UNITED STATES PATENT AND TRADEMARK OFFICE

APPLICATION NO.	FILING DATE	FIRST NAMED INVENTOR	ATTORNEY DOCKET NO.	CONFIRMATION NO.
09/943,262	08/30/2001	Tohru Ishitani	1743/193	8263

Office Action Summary

DETAILED ACTION***Drawings***

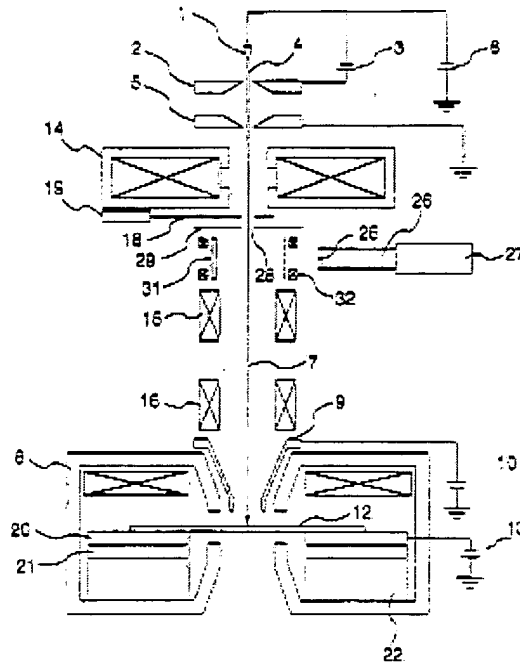
Todokoro et al. disclose a scanning charged-particle microscope having:

a charged-particle source (FIG. 4, element 1),

a lens for focusing the charged-particle optical beam emitted from said charged-particle source (FIG. 4, element 14), and

a scanning deflector for scanning said charged-particle optical beam in two-dimensional form on a sample (FIG. 4, elements 15-16),

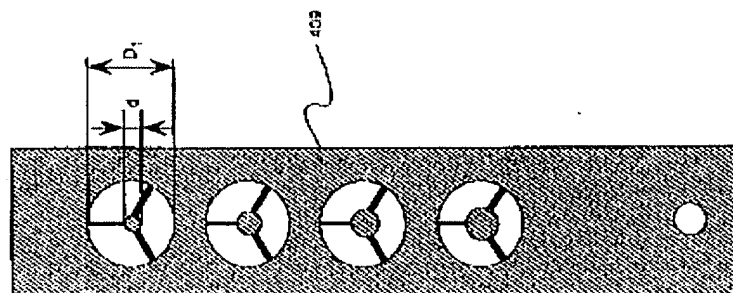
a passage aperture for limiting the passage of the charged-particle optical beam is located between the charged-particle source and said scanning deflector (FIG. 4, elements, 28-29).

Todokoro et al. does not disclose that the passage aperture formed in a plate-like body movable with respect to said charged-particle optical beam (**Referring to claims 3, 9**) includes a member for limiting the passage of the charged-particle optical beam provided at least in the center of said passage aperture, the plate-like body also includes a circular aperture (**Referring to claims 4, 8**), and wherein the scanning charged-particle microscope is characterized in that said circular aperture and said annular aperture are formed in a first plate-like body and a second plate-like body, respectively, in that said first plate-like body is provided with a charged-particle optical beam cutoff portion in addition to the circular aperture and said second plate-like body is provided with a circular aperture in addition to the annular aperture, and in that both the first plate-like

However, Kakibayashi et al. disclose a passage aperture formed in a plate-like body movable with respect to said charged-particle optical beam (FIG. 21: the element 409 is movable respectably to the charged-particle optical beam for selecting an appropriate aperture) having a member for limiting the passage of the charged-particle optical beam provided at least in the center of said passage aperture (FIG. 20-22, element 409), the plate-like body also includes a circular aperture (FIG. 21: the aperture without a limiting element), and wherein the scanning charged-particle microscope is characterized in that said circular aperture and said annular aperture are formed in a first plate-like body and a second plate-like body, respectively, in that said first plate-like body is provided with a charged-particle optical beam cutoff portion in addition to the circular aperture and said second plate-like body is provided with a circular aperture in addition to the annular aperture, and in that both the first plate-like body and the second plate-like body are provided with a movement feature (FIG. 20, elements 409, 410).
